Product Change Notification

PCN-FDC-8648-2023

Business Unit	Product Line Code	Type of Change	Action	Date of Issue
FDC - Field Device Connectors	ABN	Product Change Notification	Notify Distributors and Field	4/3/2023

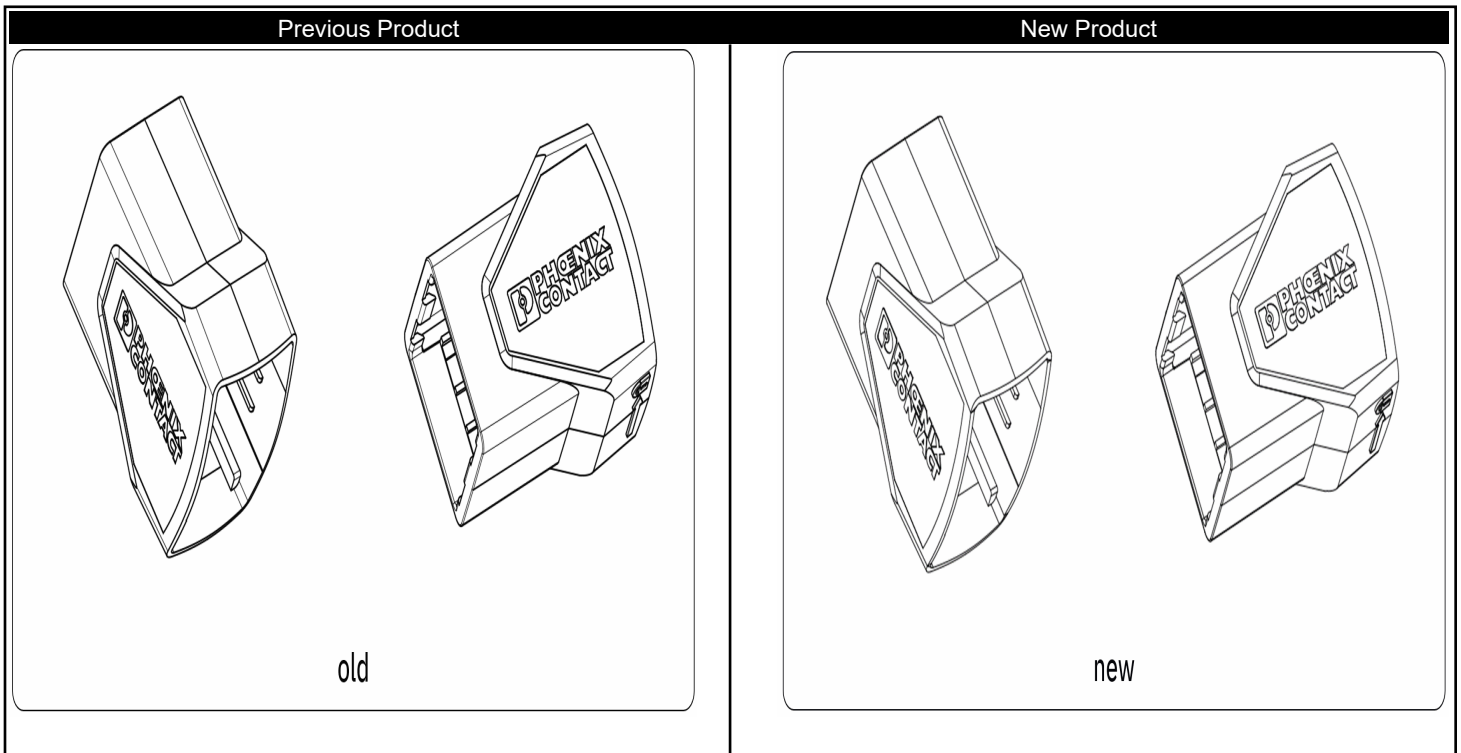
The Phoenix Contact logo and lettering on the housing component of the V14 connectors are embossed in the relief. This change provides a consistent design across the V14 push-pull ADVANCE products. In addition, we are able to improve the quality of the components.

The minimal, but necessary change in width from 22.4mm to 22.5mm allows better material distribution during the production process. All normative dimensional specifications are still met.
